CITY OF ST. PETERSBURG, FLORIDA
PLANNING AND DEVELOPMENT SERVICES DEPARTMENT
URBAN PLANNING AND HISTORIC PRESERVATION DIVISION

STAFF REPORT

Community Planning and Preservation Commission Certificate of Appropriateness Request

CITY FILE NO.: 20-90200007

Figure 1: 1951 Sanborn Map, Sheet 347, St. Petersburg, Florida, with subject property outlined

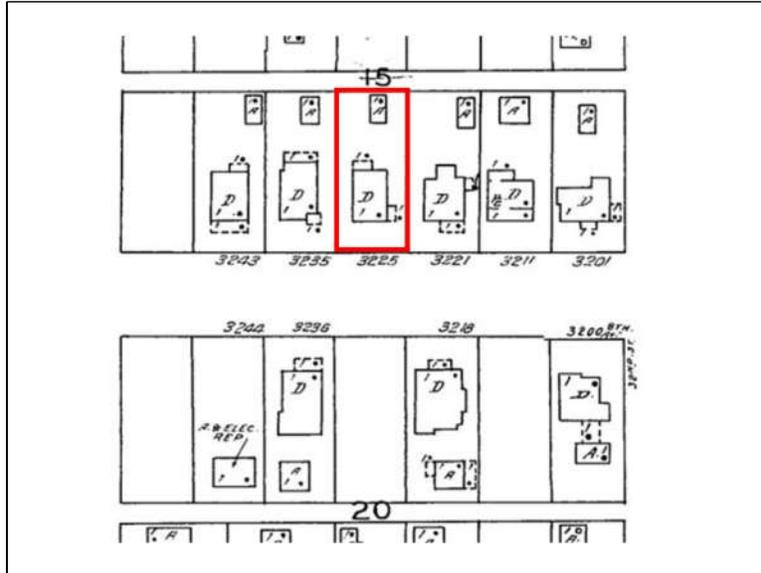
The 1932 garage is visible in the 1951 Sanborn map (Figure 1) of the area. Its demolition date is unknown.

Permit records indicate that a one-car frame garage was constructed at the subject property in 1932 when the house was relocated to the site. As shown in Figure 1, detached garages with minimal setback from the alleyway were typical of the block during the historic era. However, the 1932 garage building was demolished at an unknown date, likely prior to 1968, as a permit was issued that year for the construction of a carport. The current proposal includes demolition of this carport, as well as the construction of a new accessory structure with general similarities of size, design, and orientation/location on the parcel to historic garage buildings (see Figure 1). The construction of the garage within 6 feet of the rear property line is consistent to the original development of the property in 1932.

Figure 2: Alley-facing (north) elevation, from application

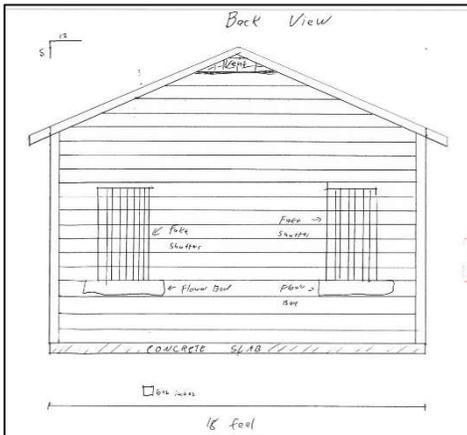
The new building will not feature alley-facing garage doors as is most typical of accessory structures in the district. Rather, the alley-facing (north) elevation will feature two false windows and flower boxes (Figure 2). This will be the sole elevation that is located outside of the property's fence line, and, therefore, directly visible from elsewhere in the district. It is, however, important to note that this exposed elevation will face the alley, which is dominated by buildings of utilitarian, albeit often historically significant, design (Figure 3).

However, the alley-facing elevation will feature false windows rather than garage doors.

Figure 4: Proposed south elevation (to face rear elevation of primary residence on property), from application

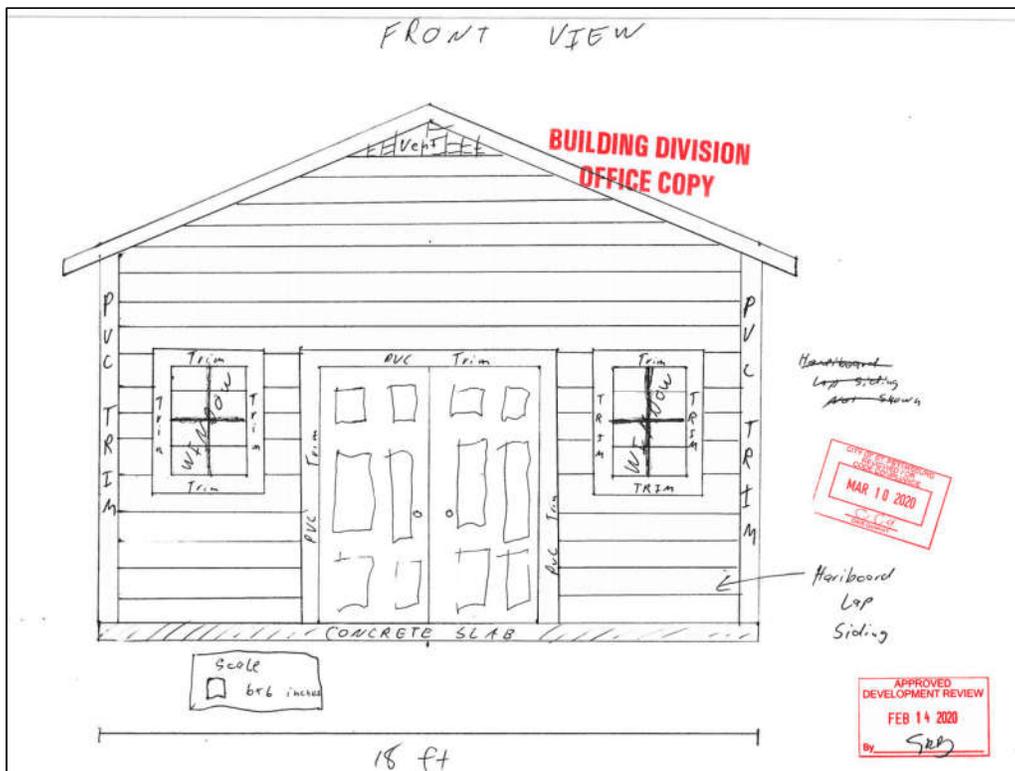
The building's entrance will face the interior of the subject property, with dual-action paneled doors flanked by two windows at the south elevation (Figure 4).

Consistent Proposed windows at the south (interior-facing) elevation are 24 3/8" wide by 36 1/4" high. Exact dimensions of the false windows at the north (alley-facing) elevation are not specified. In each case, the windows' (or alluded windows') size is vertical in orientation, which is in keeping with predominant design principles of pre-war resources in the subject district.

Consistent Windows and doors at the south elevation are evenly spaced and traditionally proportioned. Side elevations feature no fenestration, which is not entirely uncommon for utilitarian accessory structures. The false windows at the north elevation are evenly-spaced.

1. Replacement windows will feature contoured, three-dimensional external muntins.
2. Windows will be installed to be setback within the wall plane and feature a reveal of at least two inches.
3. Trim will be constructed of Hardie board or wood, rather than proposed PVC.
4. All other necessary permits shall be obtained. Any additional work shall be presented to staff for determination of the necessity of additional COA approval.
5. This approval will be valid for 24 months beginning on the date of revocation of the local Emergency Declaration.
